**Proposed Composite Development (with Flat and Retail/F&B)
with Minor Relaxation of Plot Ratio Restriction
in "Commercial (2)" Zone at 8 Lam Chak Street, Kowloon
- S16 Planning Application –
TPB Ref.: A/K22/50**

(Planning Application No: A/K22/50)

RESPONSE-TO-COMMENT TABLE

Figure: 2.1

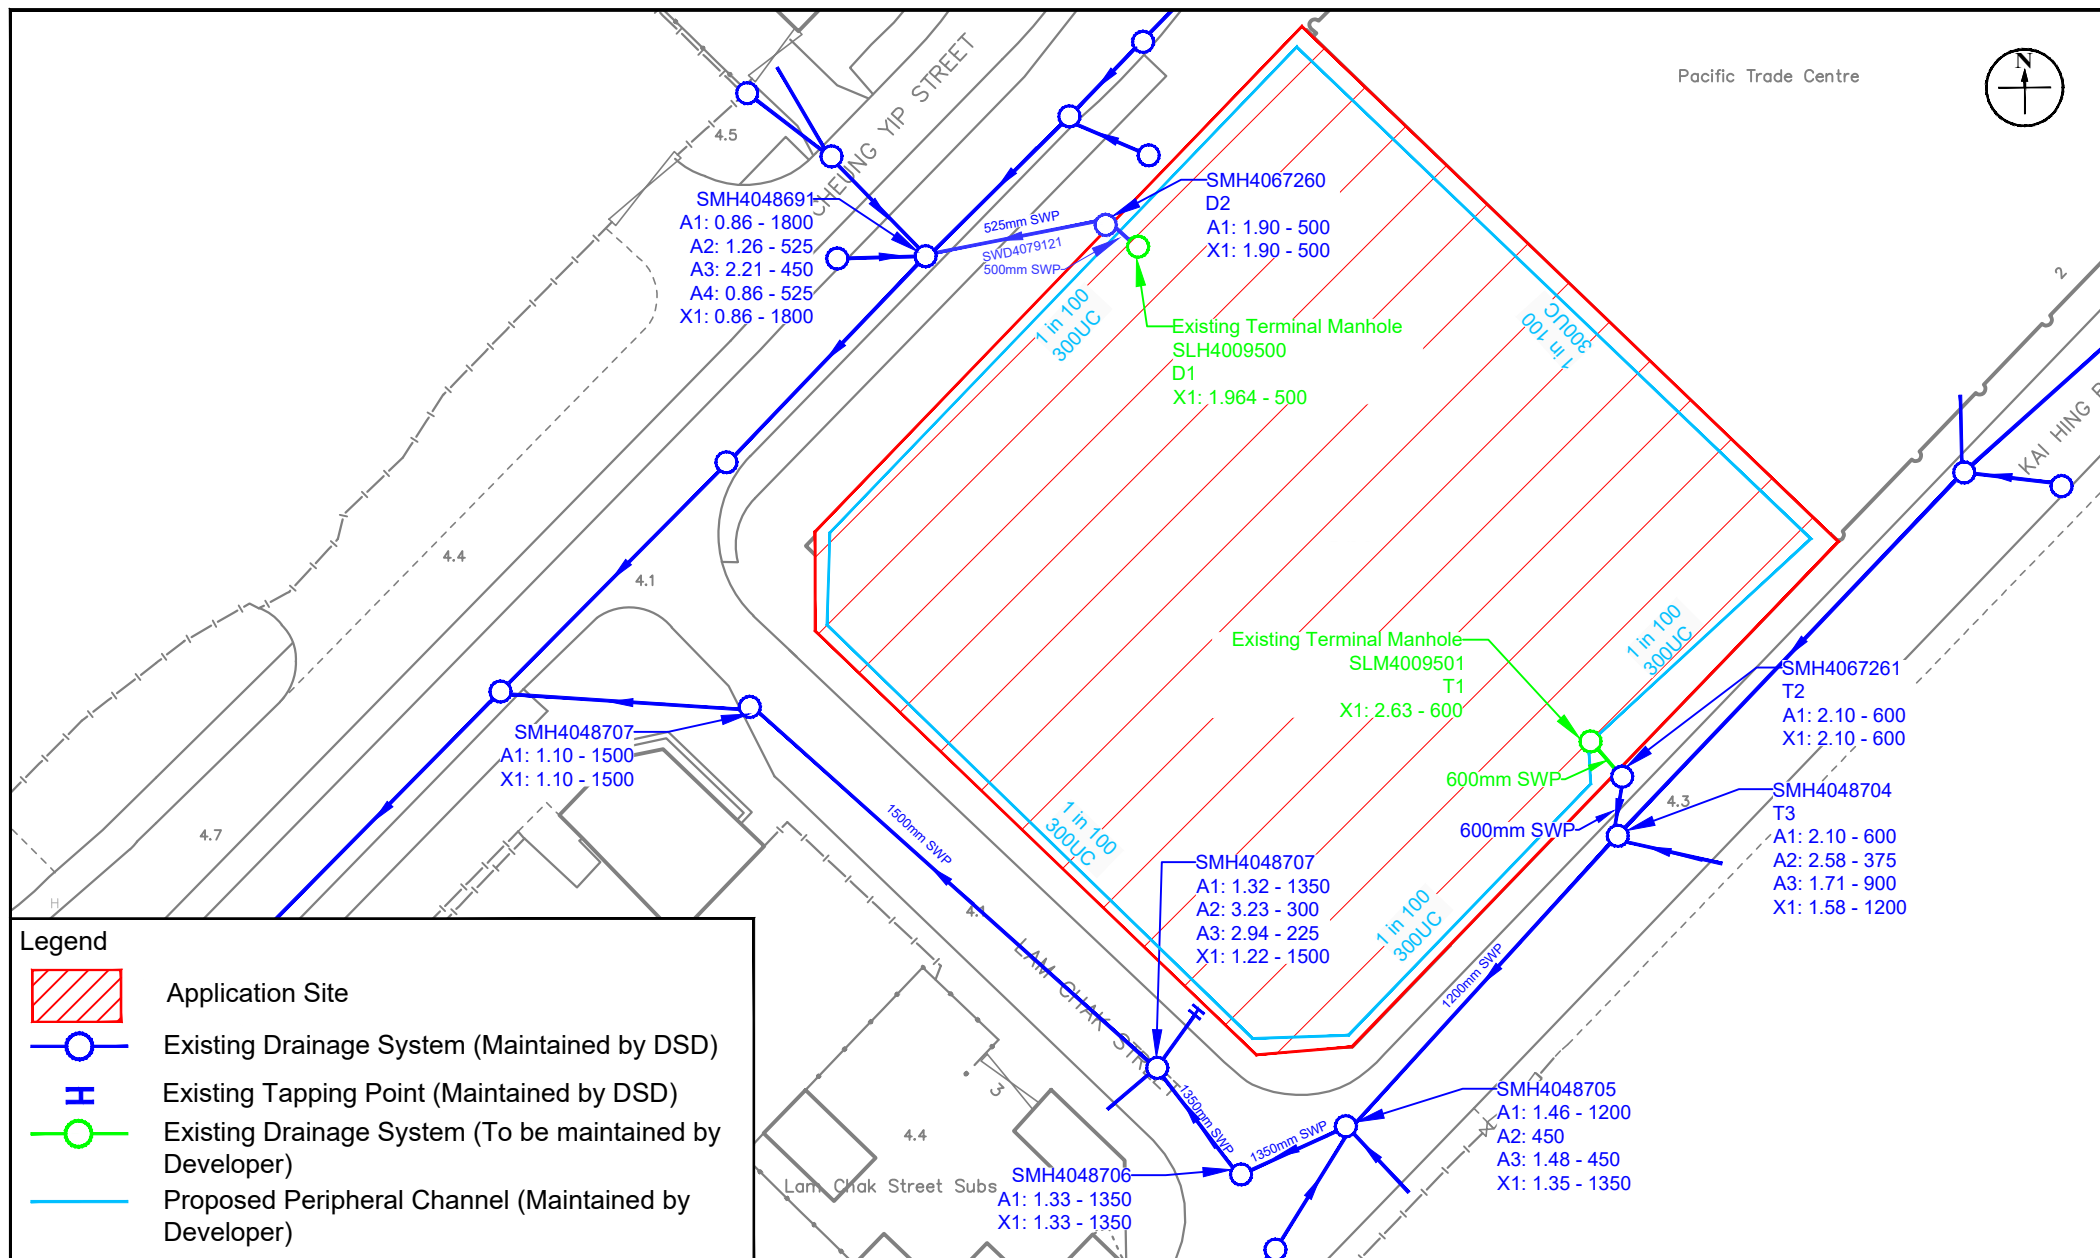
Comments	Response
(iii) Para. 2.1.3 - Please review the drains proposed to be abandoned - if "SWD4079230" should be corrected as "SWD4079120". Please also further check and verify if the concerned existing drainage pipes to be abandoned (SWD4079120 and SWD4079121) are currently idle or collecting surface runoff for what catchment, and elaborate the associated hydraulic impact if there is change in proposed drainage path of concerned catchments. Relevant hydraulic calculations should be supplemented for review in this case.	 It should refer to drainage pipes SWD4079120 and SWD4079121. These pipes are solely used to receive runoff from the Application Site. Instead of proposing to abandon these pipes, it is now assumed that the flow regime will not be altered. With no change in flow regime and reduced surface runoff due to increased greenery provision, no adverse drainage impact would be anticipated. In case detailed proposal in the detailed design stage deviates from the existing flow regime, hydraulic calculation will be provided to assess the impact due to the design change.
